ACCESS REPORT

SECTION 75W APPLICATION
BUILDING 1B

RACECOURSE PL, EVANS AVE & BARBER AVE
EASTLAKES TOWN CENTRE

MIXED RESIDENTIAL / RETAIL DEVELOPMENT

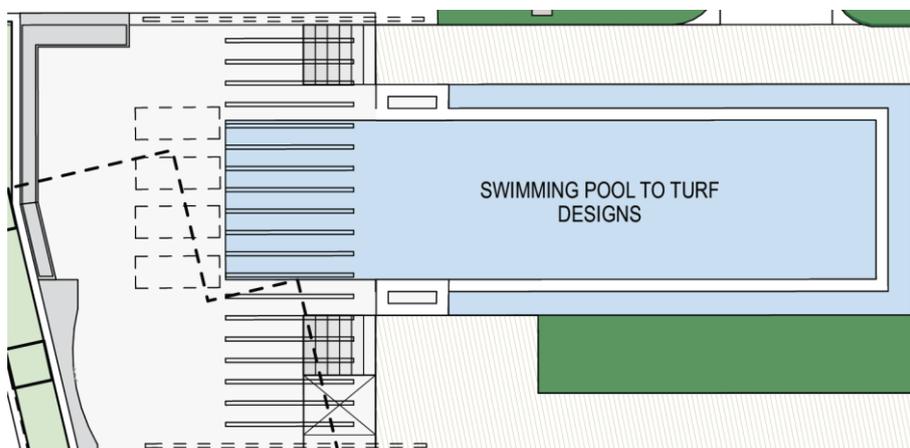
20. Podium Level Access – The plans illustrate a lift lobby with ample circulation space to exit to the outdoor terrace at the same level approach and enter a function room, gymnasium, unisex wheelchair accessible toilet and residents lobby in accordance with ASI428.1, including doorway circulation spaces, Turning and Passing Areas to satisfy D3.3 of the BCA.

21. Internal Areas of the Gym & Function Room comply with ASI428.1 to satisfy D3.3 of the BCA.

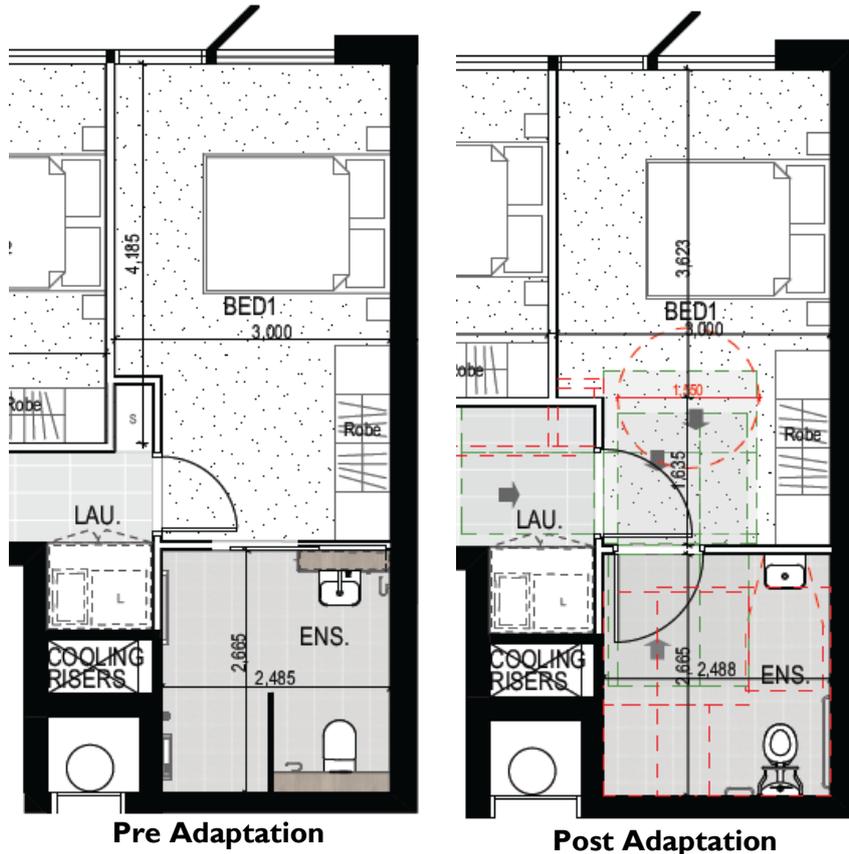
Main bedroom – The plans show the main bedroom for;

- Building 1B - 6 X 2 bedroom layout will be at least 3000mm x 5250mm providing 1540mm X 2070mm circulation space at the side of the bed and a 1000mm-1200mm on the other sides of the queen sized bed with appropriate doorway circulation spaces to enter/exit the room and access the robe area to satisfy AS4299/1428.
